Subject: Dresden and Quad-Cities Stations Supplement No. 1 to Dresden Station Special Report No. 39 and Quad-Cities Station Special Report No. 14, Analysis of Hydrogen Generation and Control in Primary Containment Following Postulated Loss of Coolant Accident, NRC Docket Nos. 50-237, (50-249), 50-254, and 50-265

Attached is Amendment No. 1 to the subject special reports. This amendment is seen on the attached pages 13, 14, 15, 21, and 22 and Figures IV.1, IV.2, IV.3, IV.4, IV.5, IV.6, IV.7, and IV.8.

> AMENDMENT #1 FEBRUARY, 1976

Figure IV.1 Hydrogen Concentration in the Drywell Following a Loss-of-Coolant Accident, No Steam Dilution

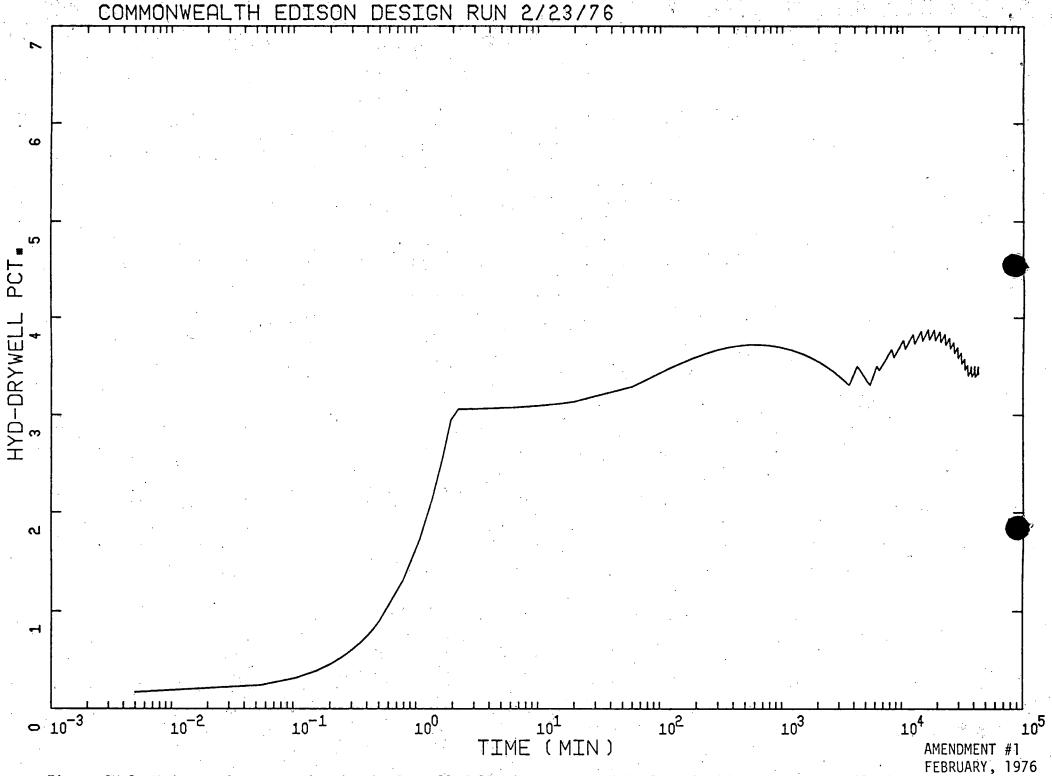
The following pages contain the changes to the original report. These changes reflect the use of the 0.18% metal-water reaction in a 7 x 7 core and as it may be seen, the results are slightly less restrictive on the system than the original report.

Figure IV.5 Hydrogen Concentration in the Drywell Following a Loss-of-Coolant, Steam Dilution

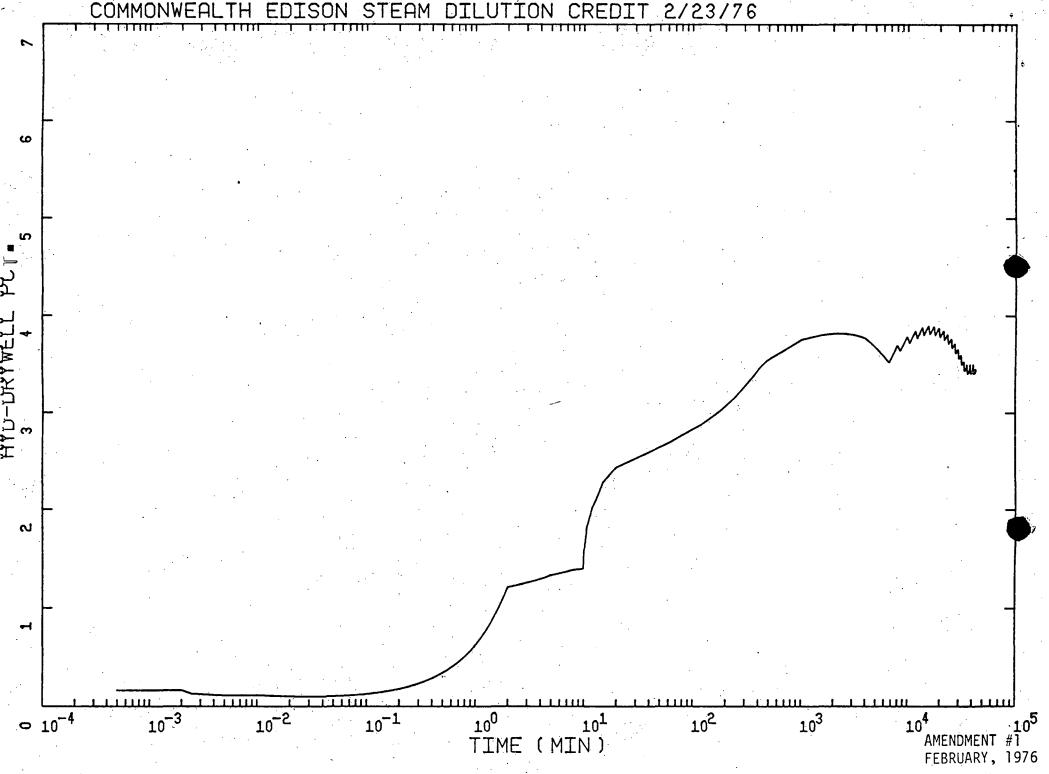
The results of this analysis shown in Figures IV.5 through IV.8 show that the ACAD System operation would not be required until 445 minutes (7.42 hours) after the accident, a factor of over 3 greater than the design case. Since the system would not be required to operate until much later than the design case, the required air injection rate would be 20% less than the design case. As a result of the slower air injection rate into the two volumes the pressure which requires the initiation of
